Historic Architectural Review Commission

Staff Report Item 2

Meeting Date:	October 28, 2014
Applicant:	Stefano de Luca, Architect
Application Number:	H14-01-1351
Address:	#500 Duval Street
Description of Work:	Renovation of storefront windows. New egress door and fire safety equipment at Old Kress Building.
Building Facts:	<p>The historic building is listed as a contributing resource. The two story masonry vernacular structure was built in 1918. The building is located on the south west corner of Duval and Fleming Streets. The structure will be converted into a CVS Store. The historic Kress signs will not be altered or removed.</p> <p>In October 23, 2012 the Commission approved plans for revisions to the first floor façade in order to match original openings. The design was never executed.</p>
Guidelines Cited in Review:	Commercial Storefronts and Signage (page 46), specific guidelines 1, 2 and 5.

Re: **HARC Certificate of Appropriateness**
CVS #10169
500 Duval Street
Key West, FL 33040

1 SCHEME-2 FRONT ELEVATION (NORTH)
SCALE: 1/8"=1'-0"

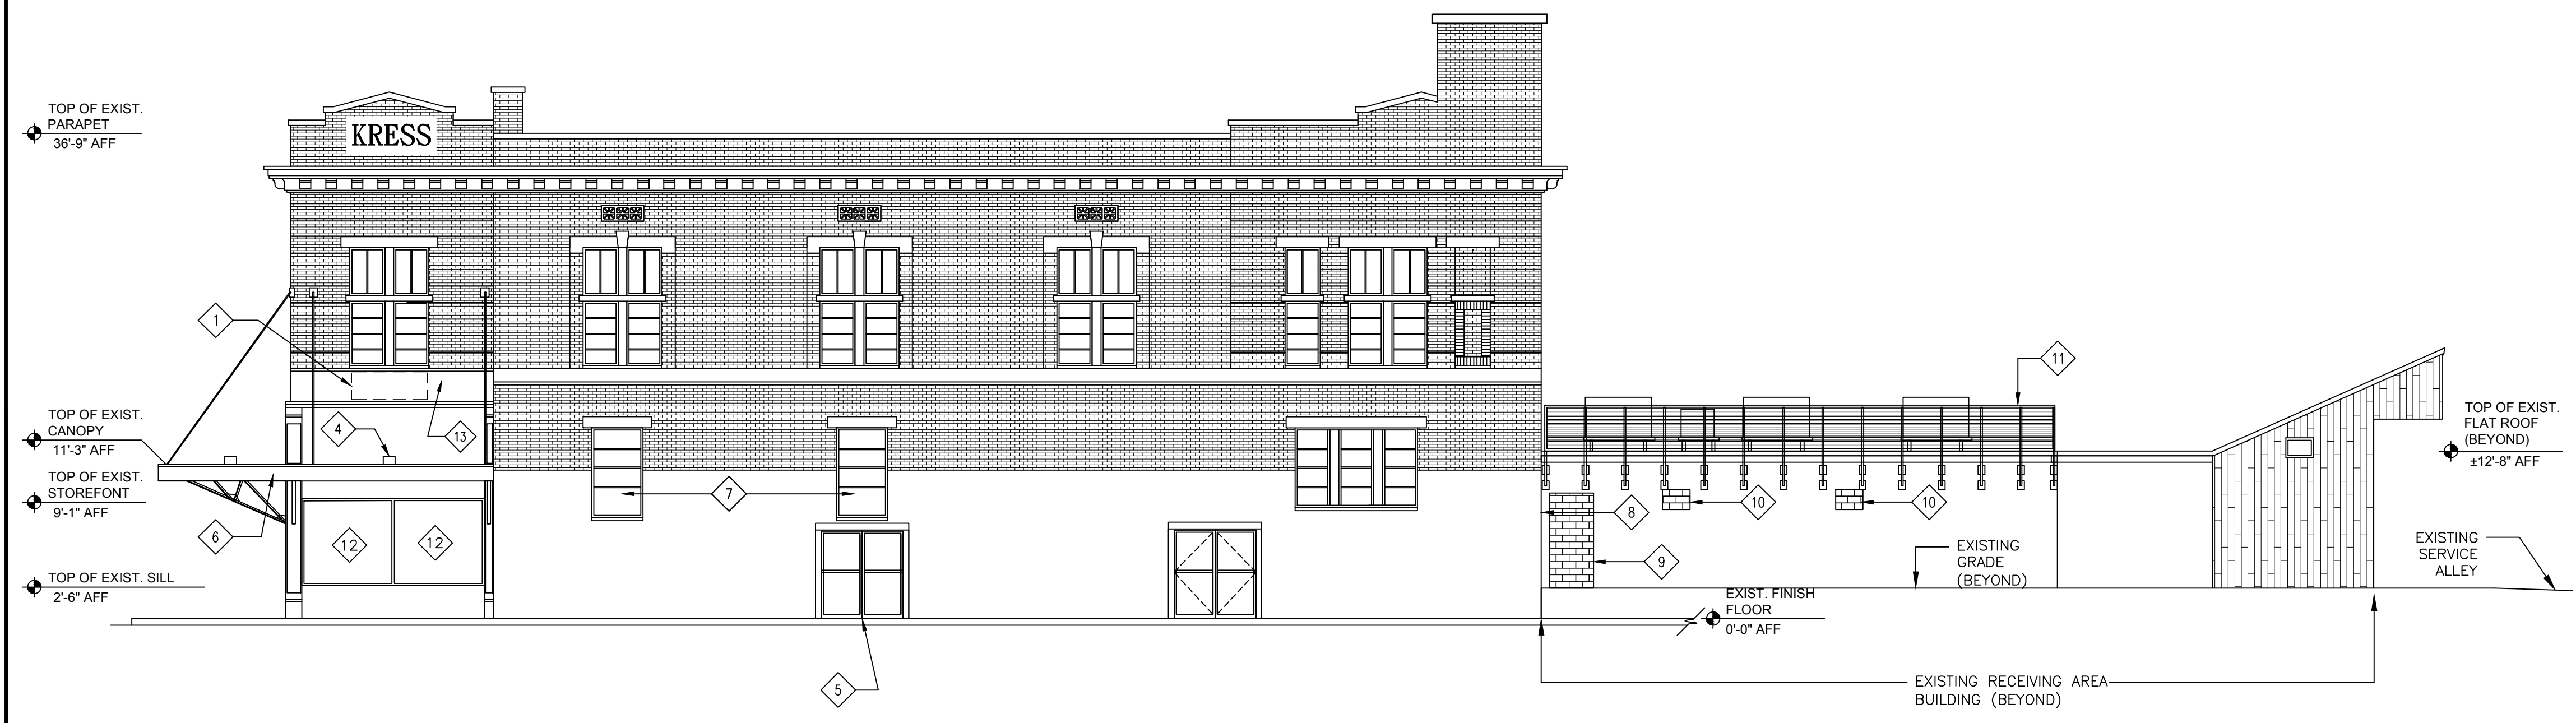
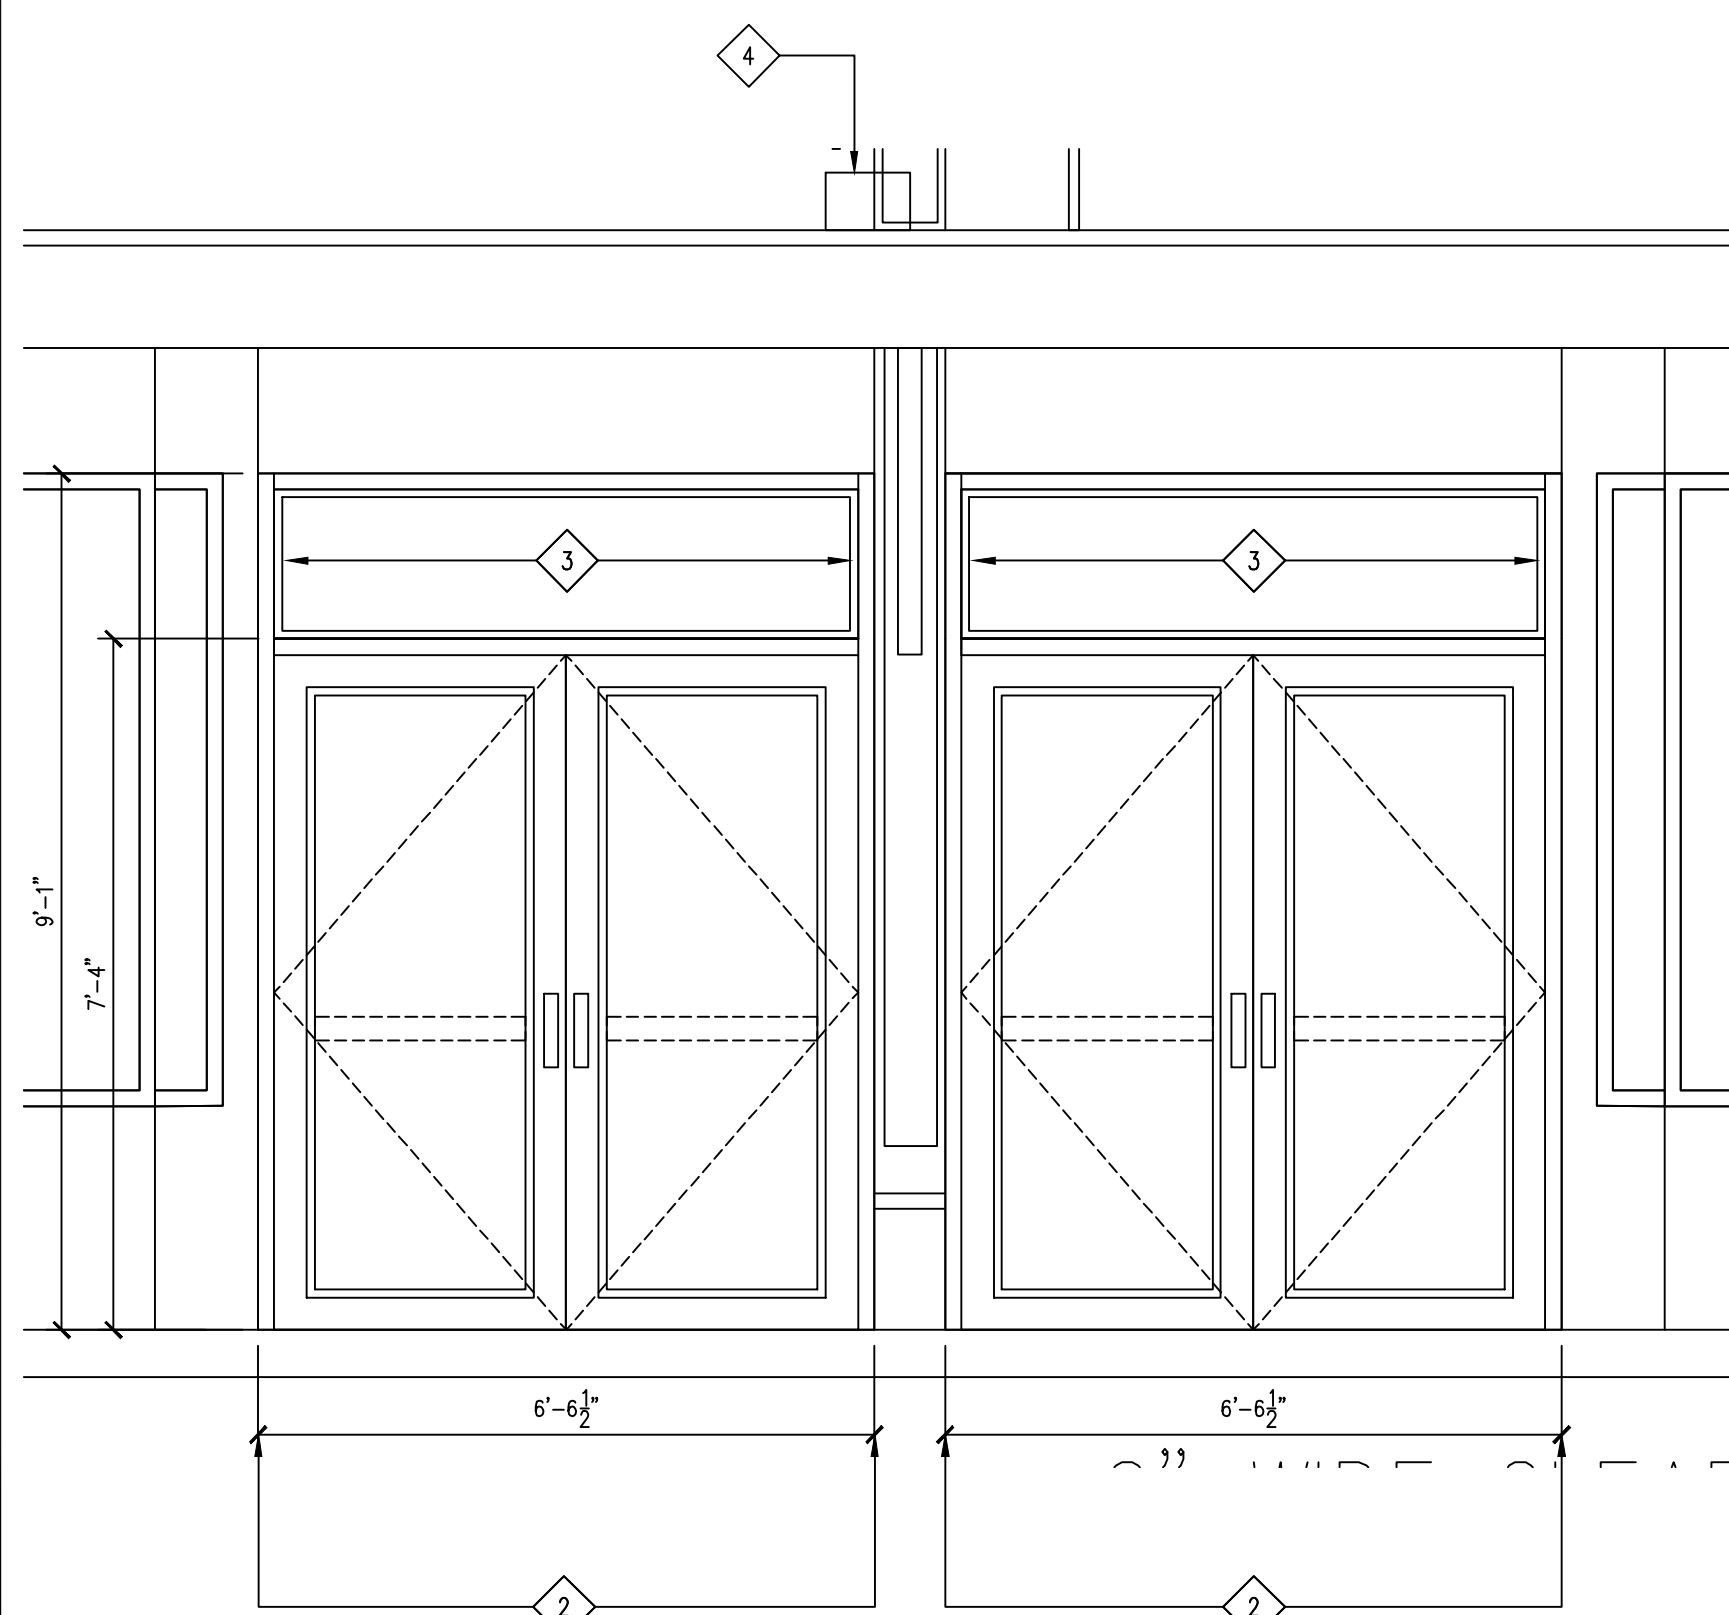
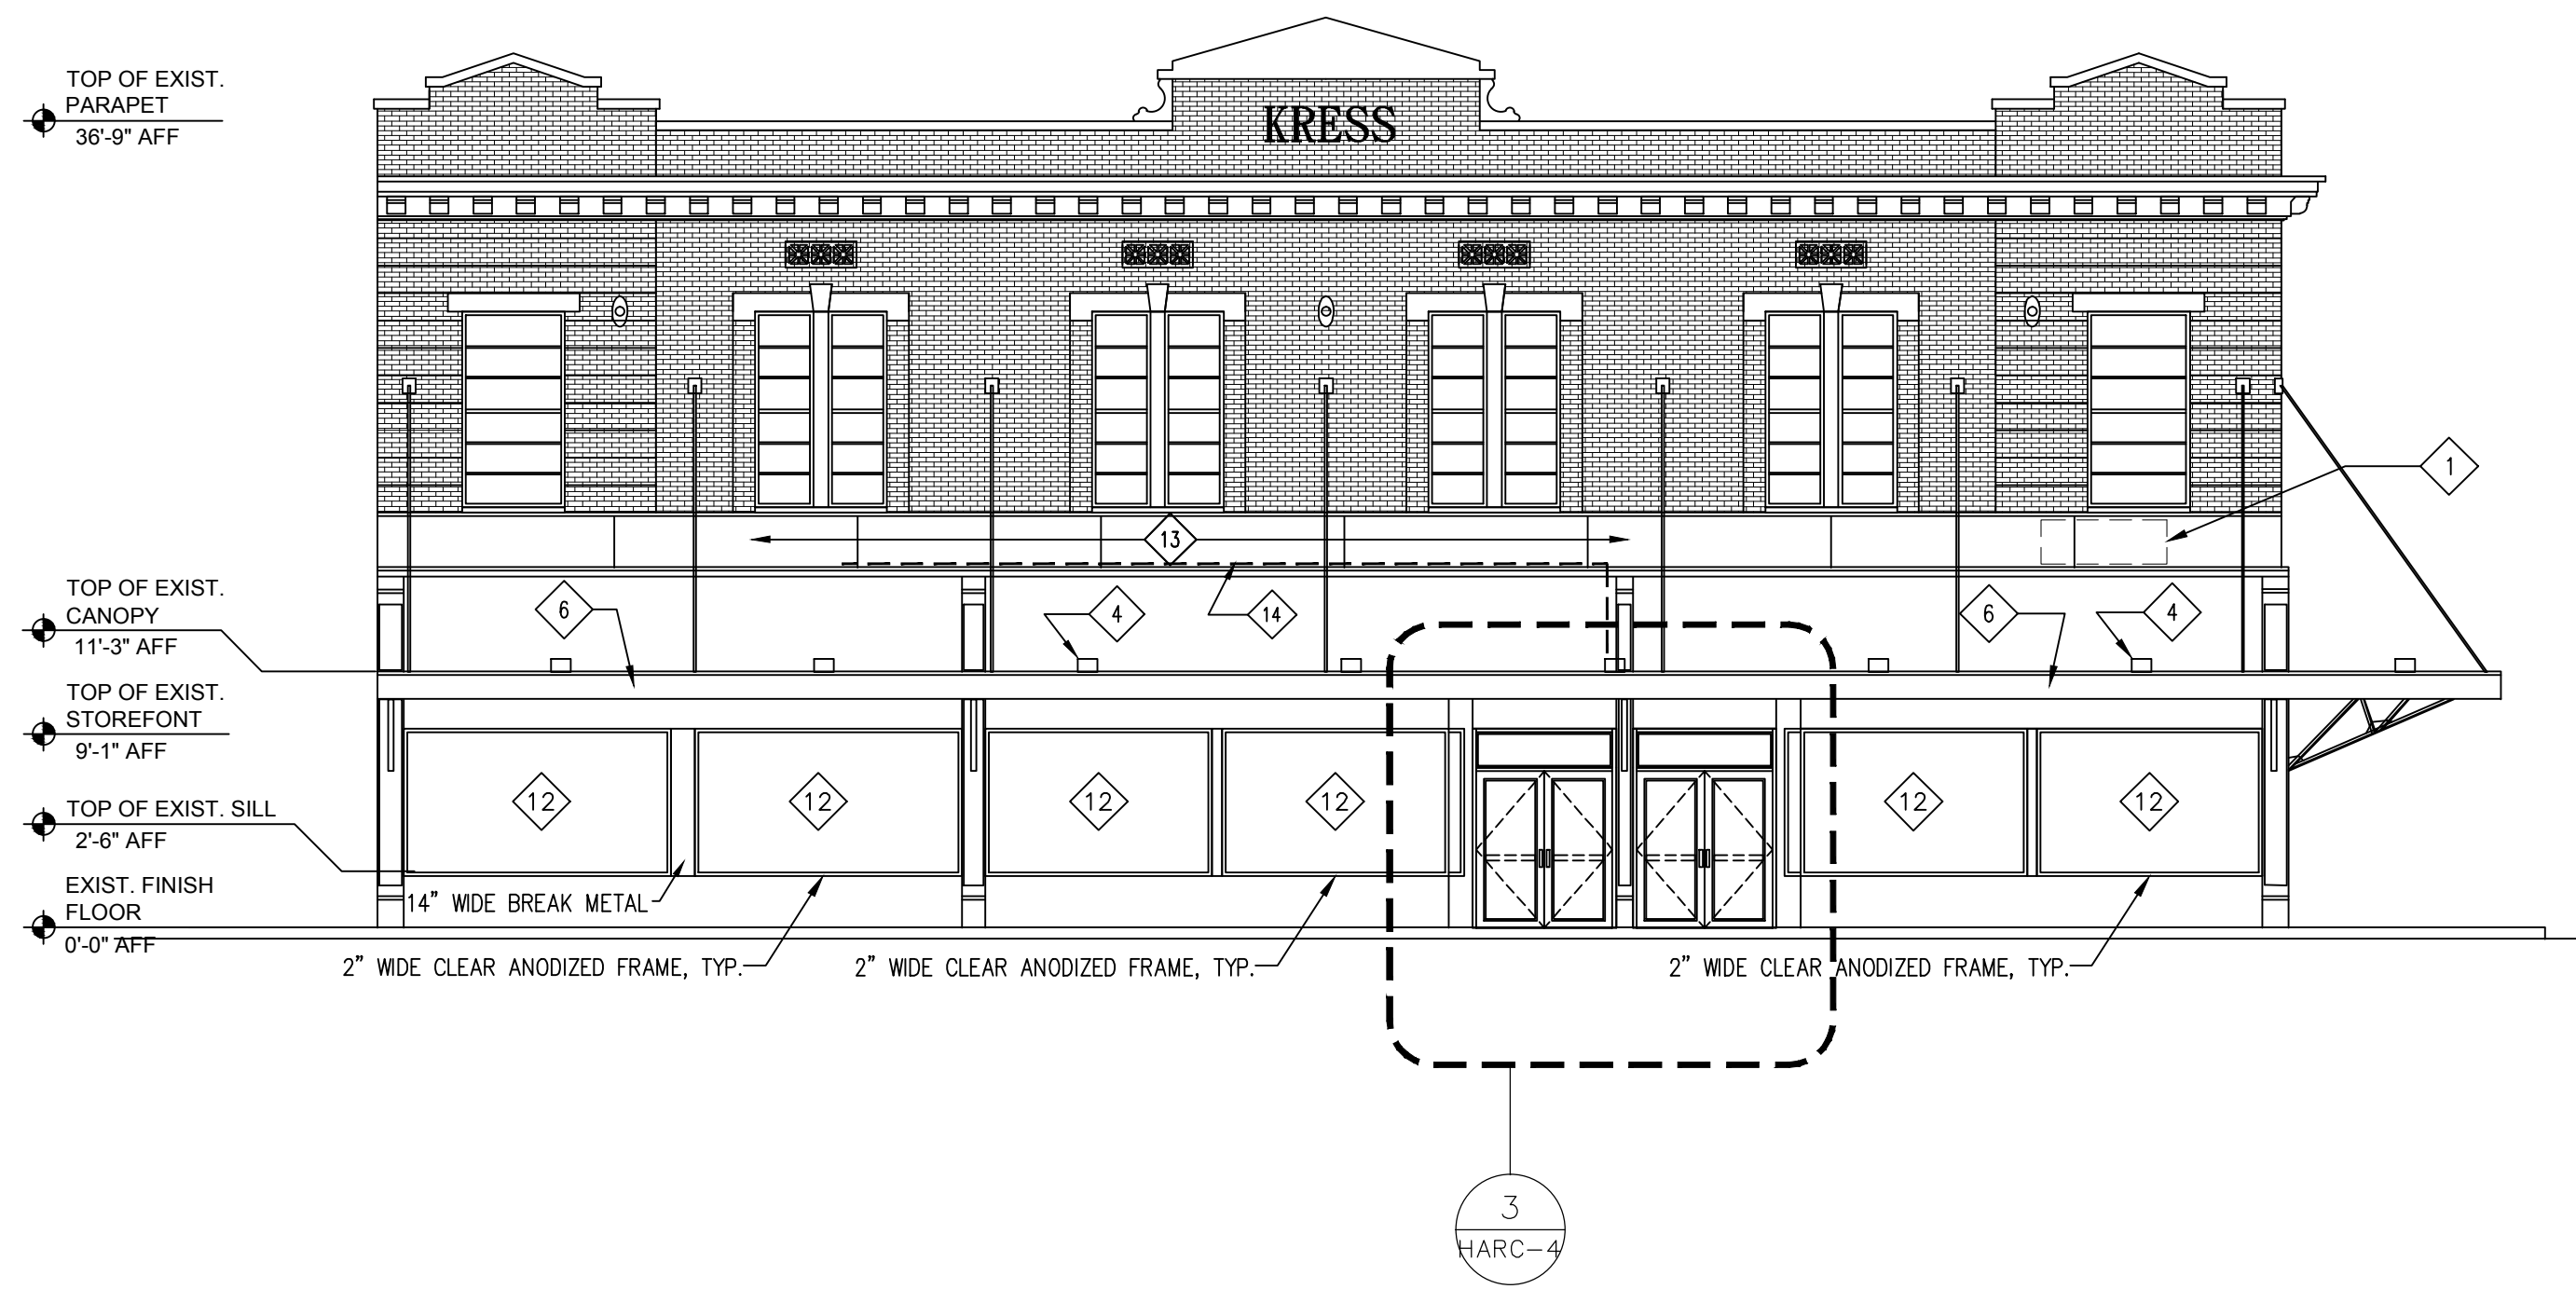
Scheme 2- Current single panels on Duval will be split into two unequal panels of glass, approximately 4' and 8' wide. The Fleming storefront will be replaced to match existing number and size of panels.
